NEL Report No. B-1777
Report of Test on Horns, Short Projector, Types H-8 and H-9

DATE 29 August 1941

Report of Test on Horns, Short Projector, Types H-8 and H-9

Submitted by Benjamin Electric Manufacturing Company,
Des Plaines, Illinois

PLATE 2

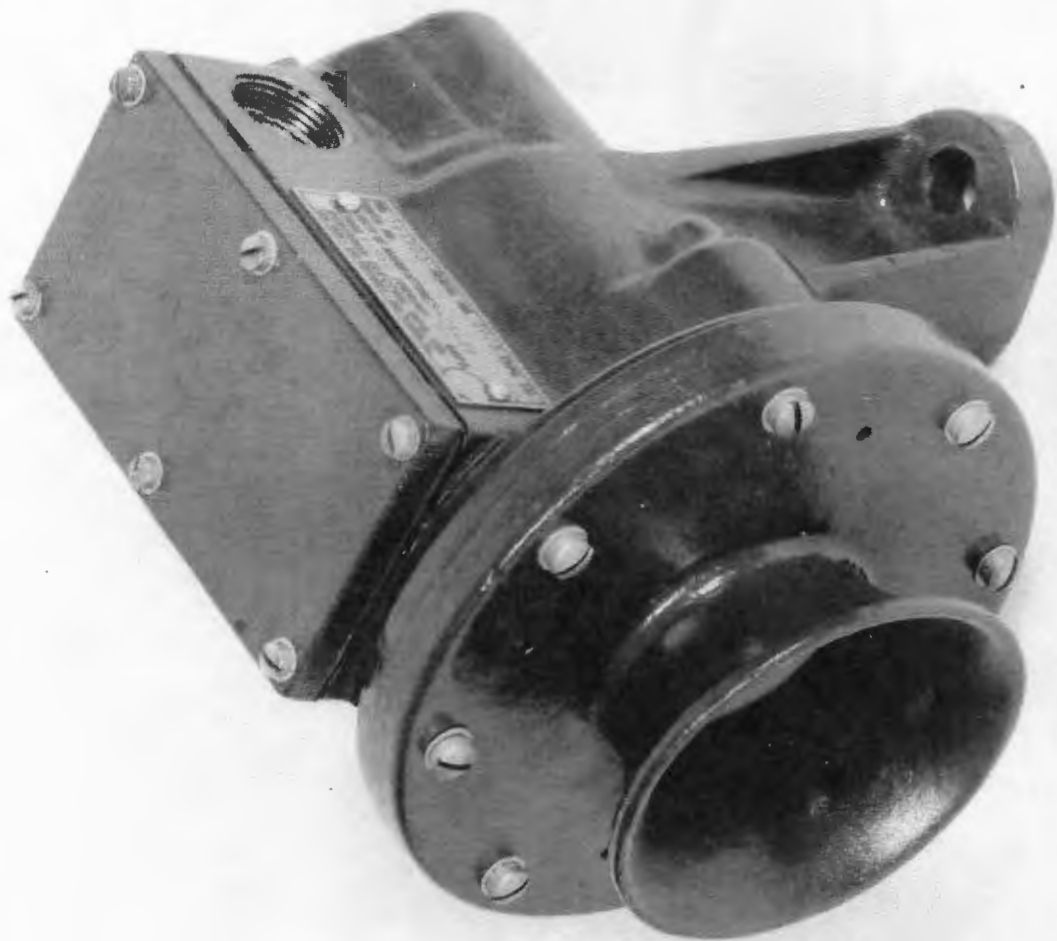
(b) The case design is considered of great improvement over the one furnished under current contracts, in that it permits free access to the adjustment screw. Mechanically, the short cast projector is considered an improvement over the long one as it is very unlikely to be broken off.

(c) The adjustment screw should be of larger diameter to prevent wringing off at the section containing the steel insert.

15. The case design is considered of great improvement over the one furnished under current contracts, in that it permits free access to the adjustment screw. Mechanically the short cast projector is considered an improvement over the long one as it is very unlikely to be broken off.

16. The adjustment screw should be of larger diameter to prevent wringing off at the section containing the steel insert.

(b) In view of the improved mechanical features incorporated in this design, it is recommended that the manufacturer be invited to submit modified samples for test.
